EXTRANEEOUS VOLTAGE

EVALUATION OF TEST DATA

Farms of Lonnie Nelson and Darrell Franze

Report Prepared on Behalf of and Submitted to
Minnesota Department of Public Service

SOMATIC CELL COUNTS (Lonnie Nelson)

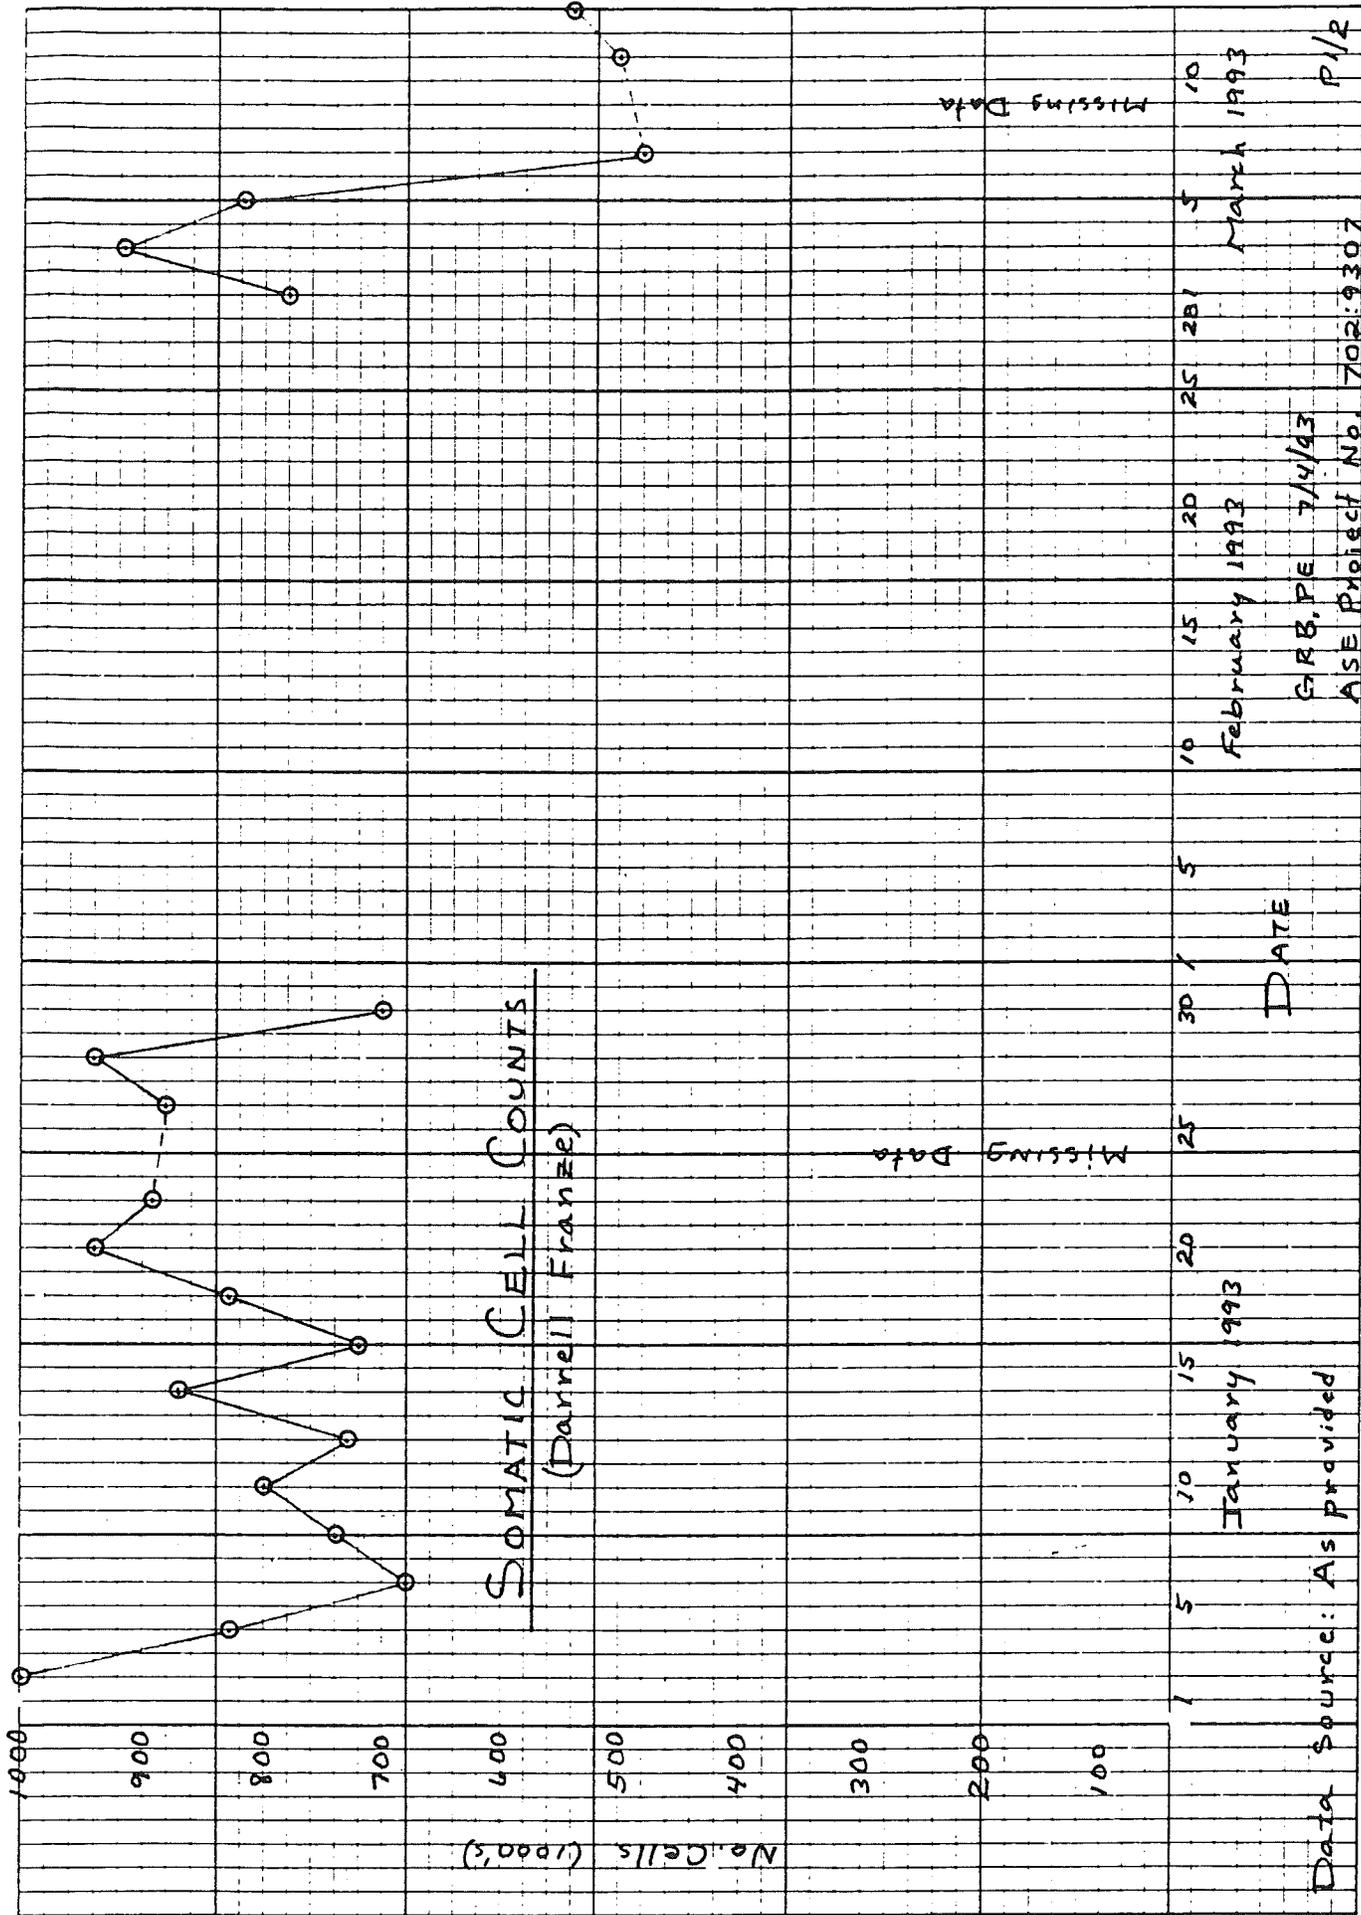
Variations in water intake appear to be within reasonable limits although both are on the low side for herds that are supposedly producing 50+ lbs. of milk per cow per day. Somatic cell count data are insufficient to establish any trends. However, the data do indicate that both herds have a very severe level of udder infection, i.e., mastitis.
